SPEL HYDROCHANNEL INDEPENDENT EVALUATORS JOINT REPORT

485-01_SQIDEP_Assessment

Date 19 June 2021

Client Stormwater Australia

Figure 1 Reported rainfall and monitoring records.

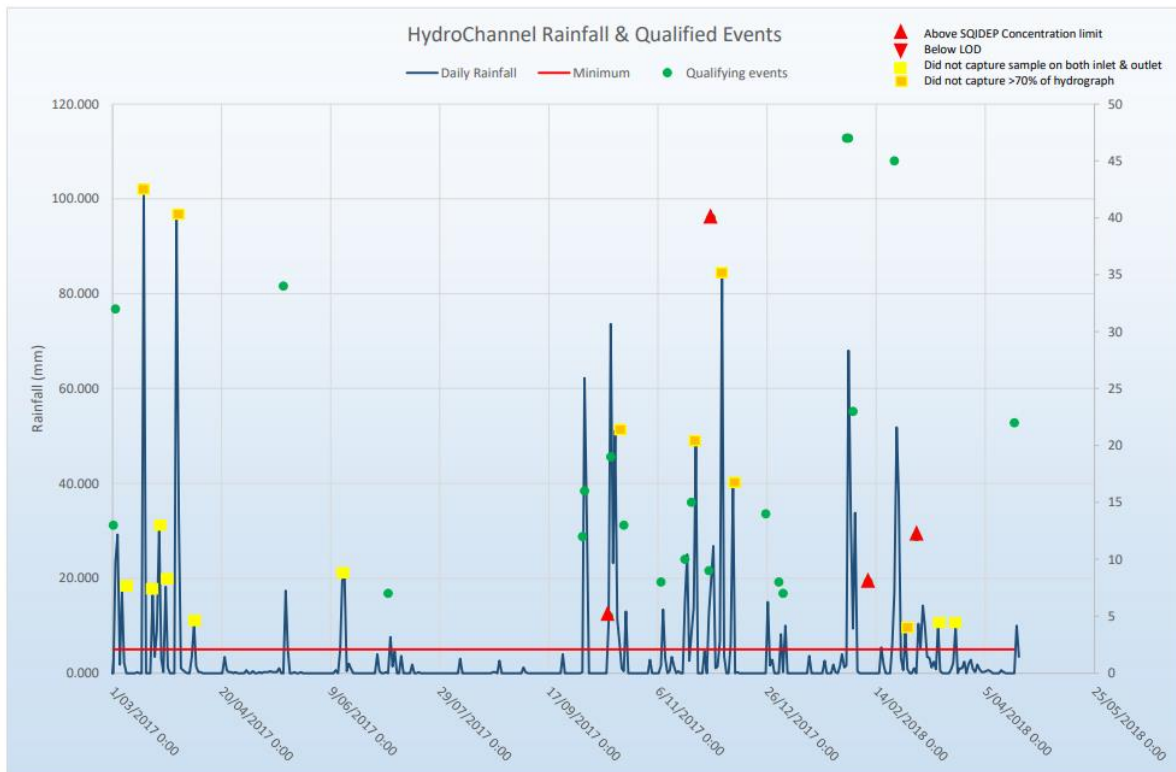
We have reviewed all storms that were excluded from the data set and a summary of these as provided in the submitted information is shown in Figure 5.

The chart shows that there were 6 recorded storm events, intense events with an average depth of over 50mm which failed to capture more than 70% of the hydrograph and were therefore discarded. There were another 8 events which did not manage to capture both inlet and outlet samples, and these were associated with events of lesser magnitude (i.e. less than 50mm). These are distributed throughout the sampling program and are, with number at the start of the program, and are likely explained by a commissioning phase.

More significantly, the qualifying events appear to be captured across the entire duration of the monitoring program, and results indicate a variance in inputs, outputs and treatment efficacy across all pollutants.

A “cherry picked” dataset would, by definition, only include events with good performance. The duration of the monitoring period, which is considered relatively short at 13 months, is indicative of a study which did not wait for high performing events to occur.
